Addendum #1

24 September 2024

Staff Entrance Upgrades
Blaine House
Augusta, Maine

1 RAMP FRAMING PLAN
SF101 SCALE: 1/4"=1'-0"

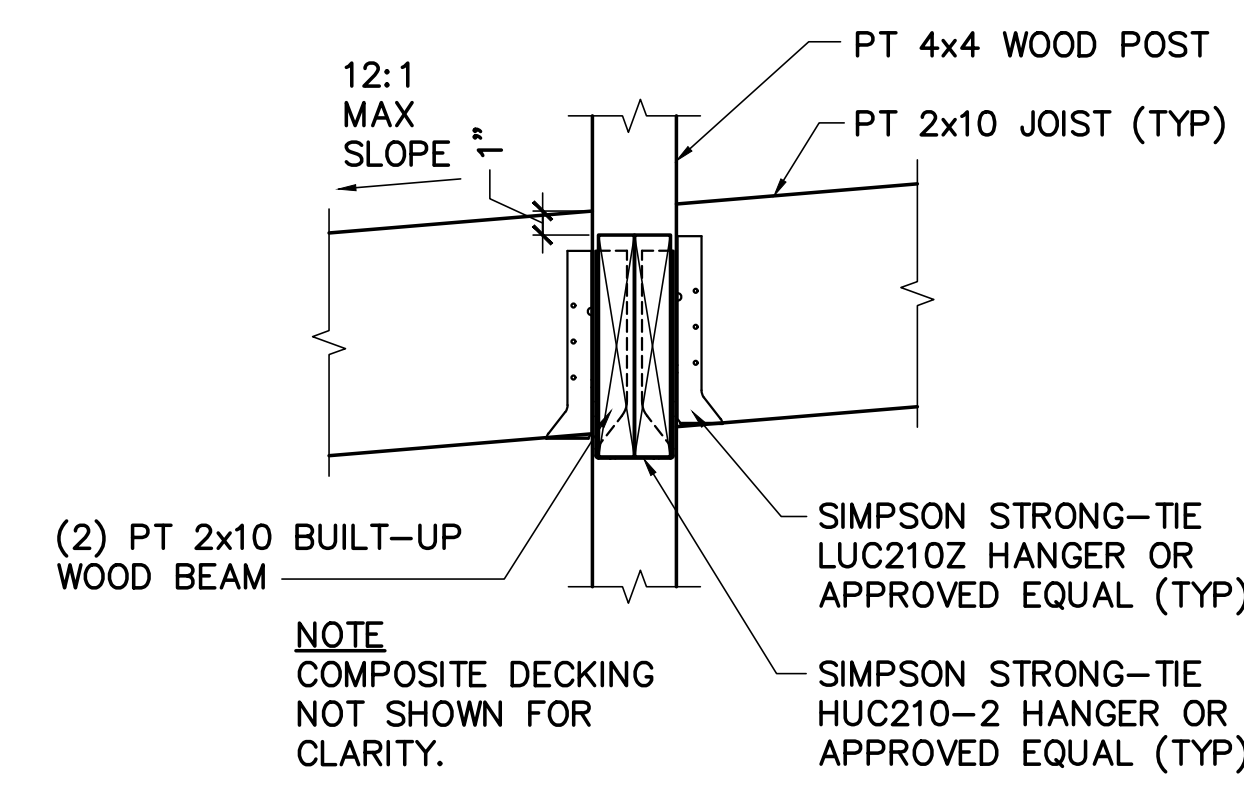
1. 1/SF101 **ADD** note "RAISE ENTIRE EXIST DECK IN ACCORDANCE TO DETAIL 4/SF101".
2. 1/SF101 **ADD** "EXIST JOISTS AT 16" ± OC (TYP)".
3. 2/SF101 **CHANGE** scale to 1-1/2" = 1'-0".
4. 3/SF101 **CHANGE** scale to 1-1/2" = 1'-0".
5. **ADD** Detail 4/SF101 "JOIST CONN TO EXISTING DECK JOIST".
6. **ADD** Detail 5/SF101 "JOIST CONN NAILING PATTERN".
